Informal document **GRSP-49-33**  
(49th GRSP, 16 - 20 May 2011,  
agenda item 11)

ECE 17 – draft proposal

## Detachable head restraint

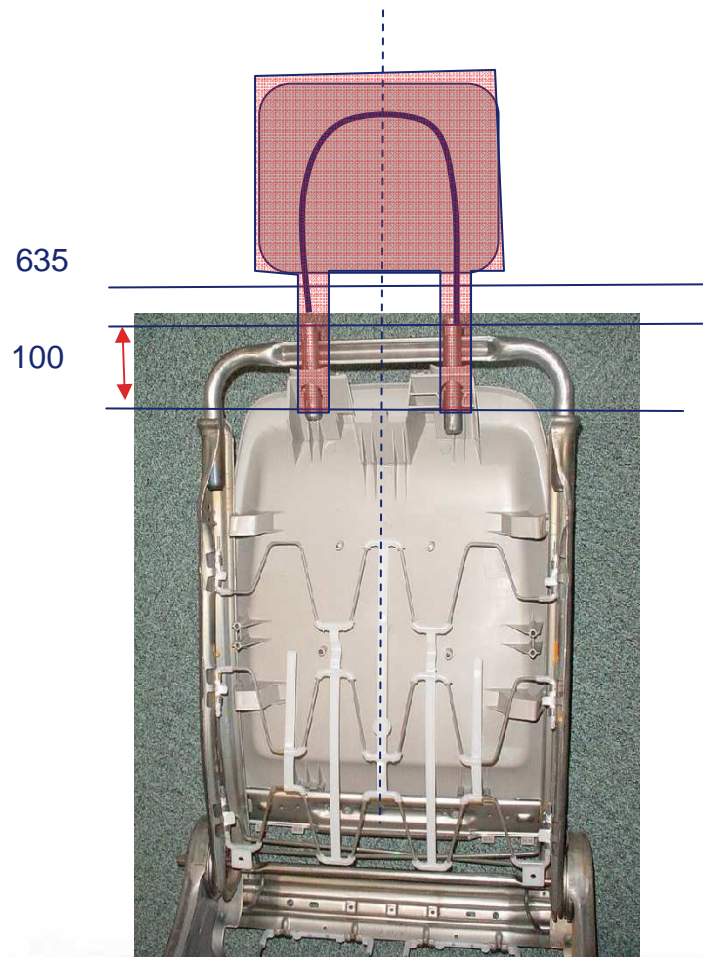
- Which head restraint parts are taken ?

-> **Application :**  
**Only head restraint fixations and inserts are used to verify the radius from the front (parts over 50 Shore A)**

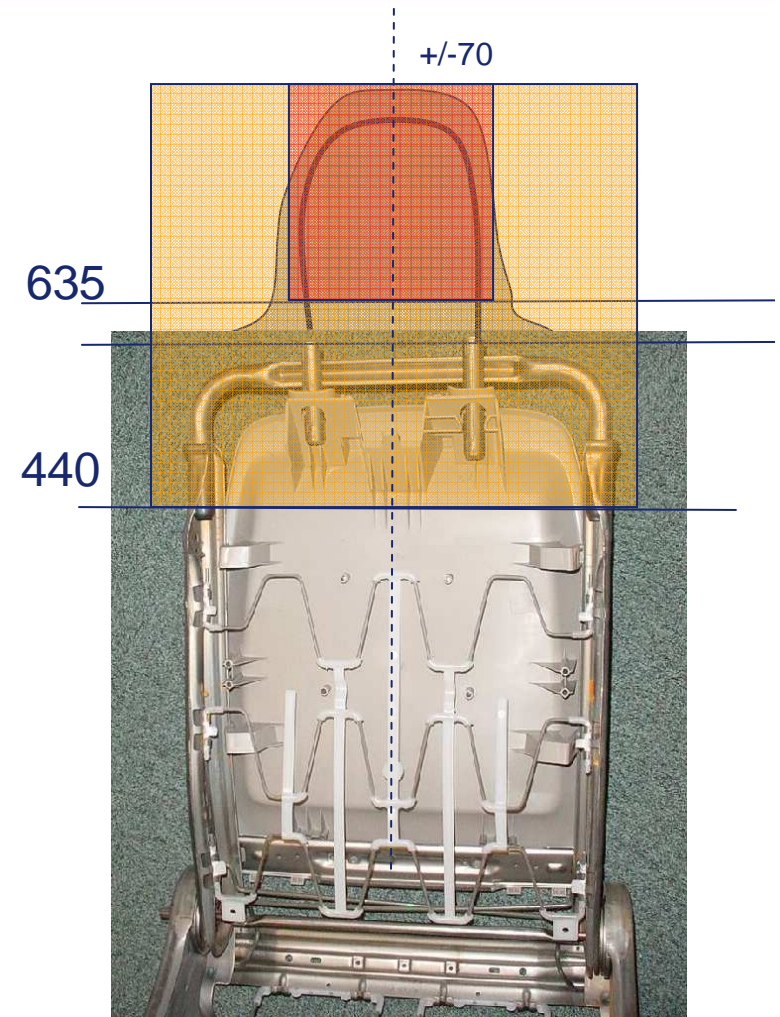
- Head restraint parts situated in zone 1 (red) or 2 (orange) must meet radius requirements from the front

-> **Problem : it is not clear which parts of the seat are part of the integral head restraint**

Comparison with parts verified with detachable head restraints

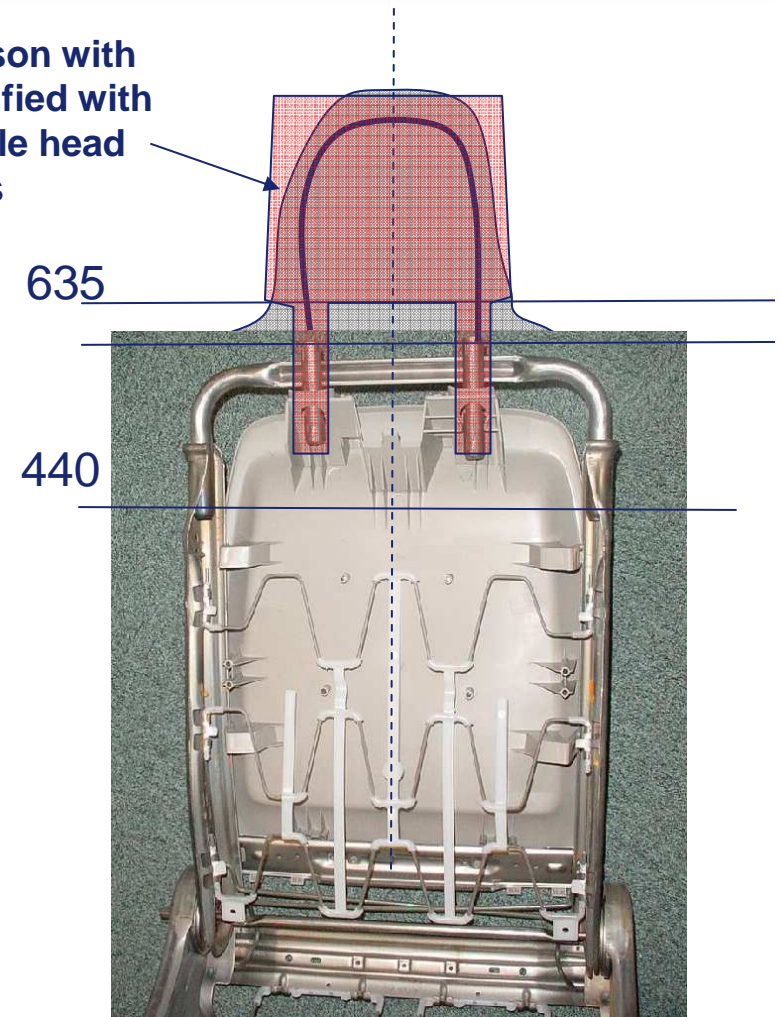
- **Problem : what is a part of the integral head restraint ?**
- **The seat structure parts did not change, only the foam volume was altered -> therefore the area where the radius are checked shall not differ significantly from seats with detachable head restraints**

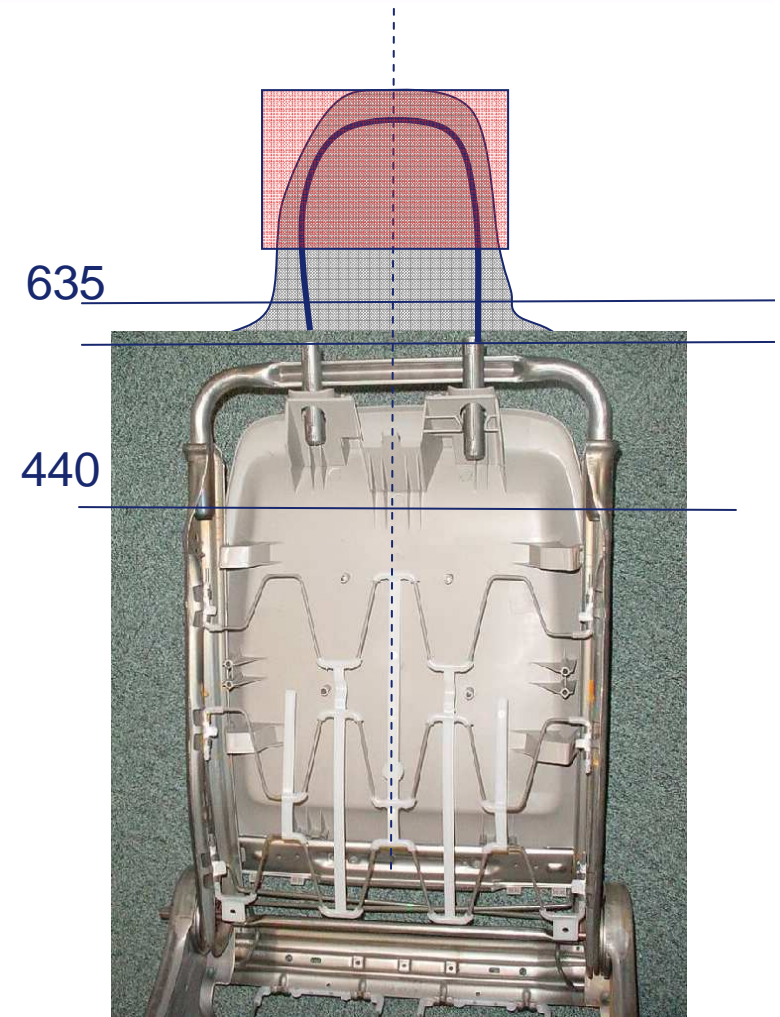
- **Problem** : what is a part of the integral head restraint ?
- **Alternative 1** : definition of GTR 7 : any seat trim over 700mm and within +/- 85mm

**this area is smaller than the area of detachable head restraints and therefore not appropriate**

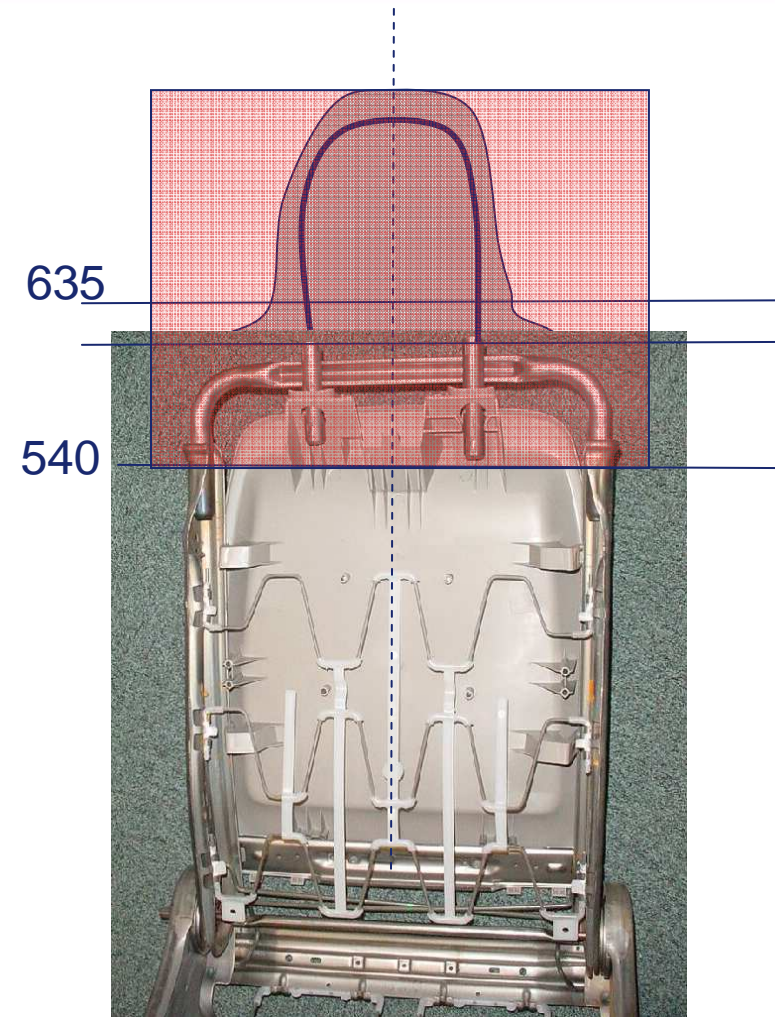
- **Problem : what is a part of the integral head restraint ?**
- **Alternative 2 : any part over 540mm (mentioned for gap and luggage crash test application)**

**this area would define that plastic covers and the whole width of the seat structure is a head restraint  
-> no need to have a bigger area than normal head restraints**

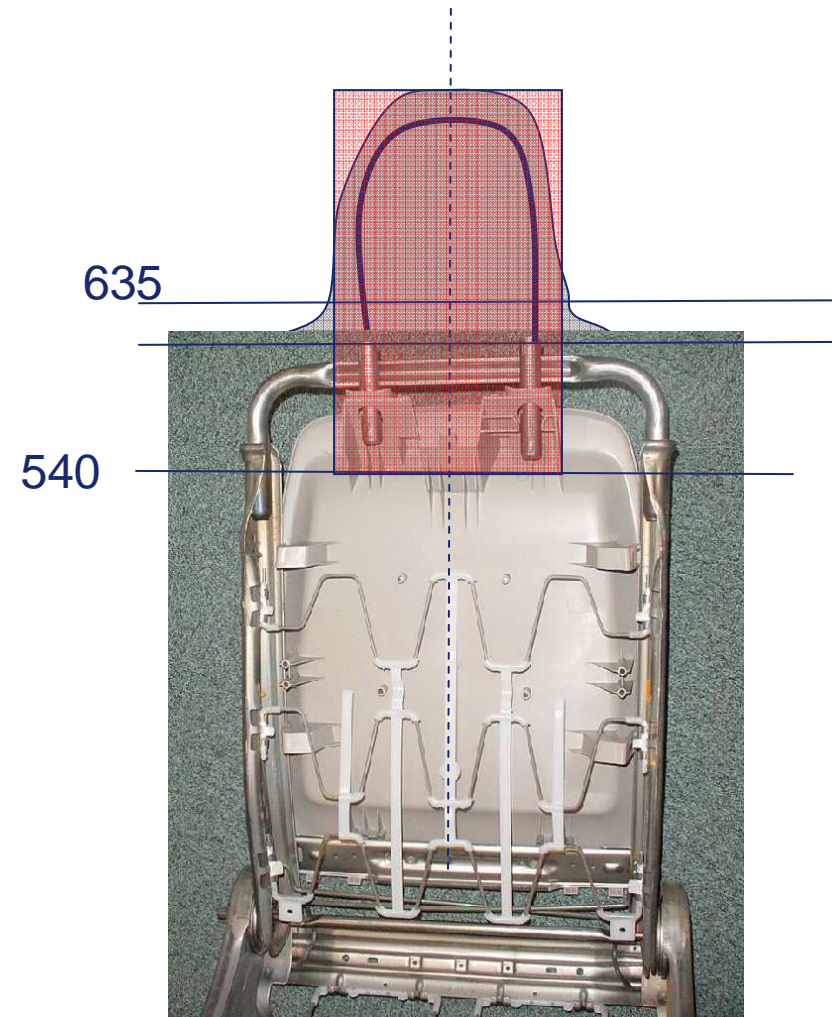
- **Problem : what is a part of the integral head restraint ?**
- **Alternative 3 : compromise of 1 and 2 :  
for integral head restraints the limit is a line at 540mm perpendicular to the torso line within +/- 85mm.**

## Conclusion

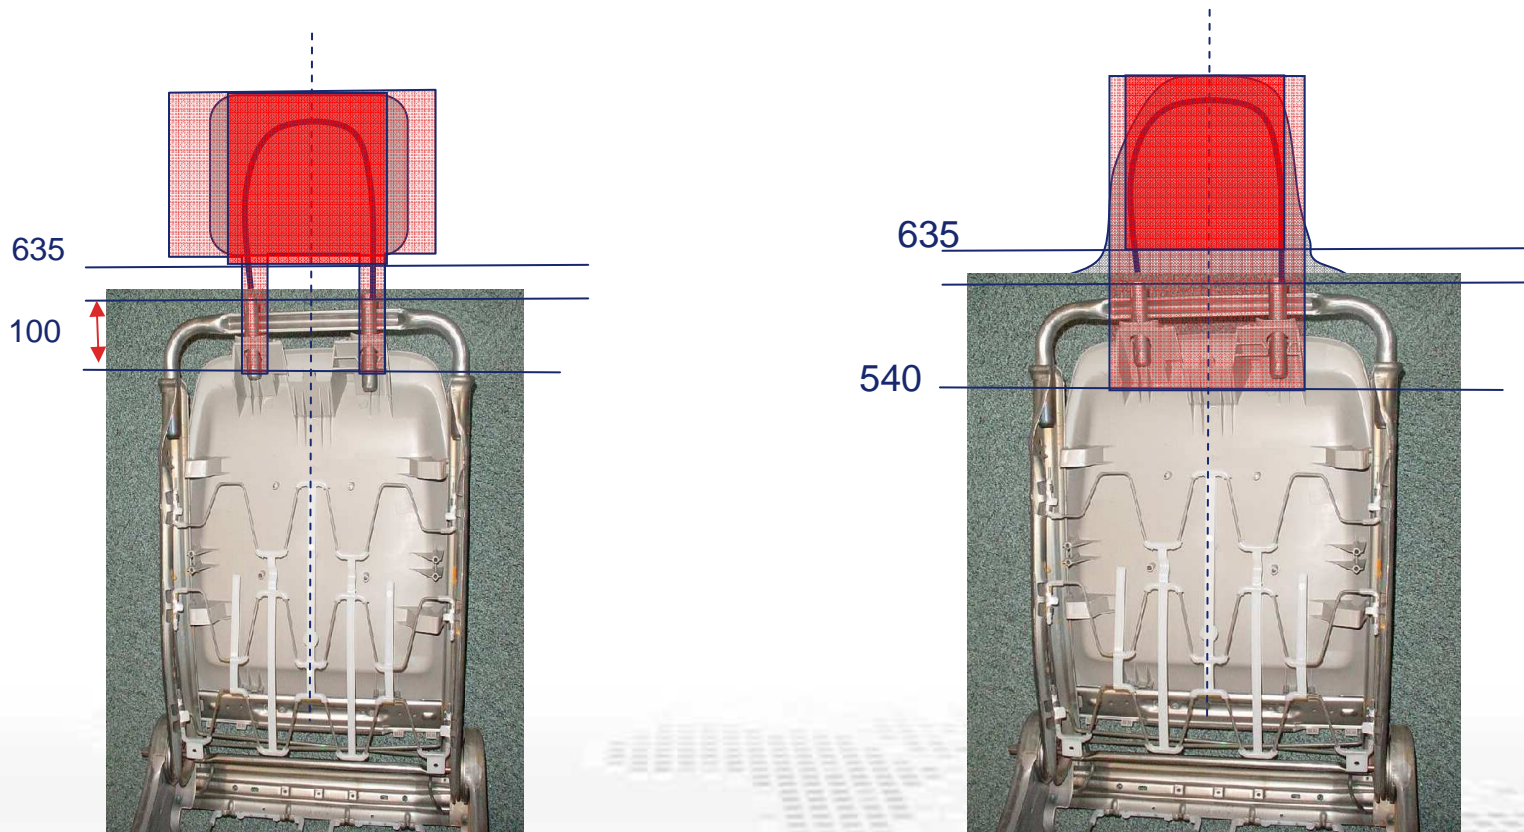
**Alternative 3 is the best compromise to define the area where radius apply from the front to integrated head restraints and which avoids to penalize such restraints**
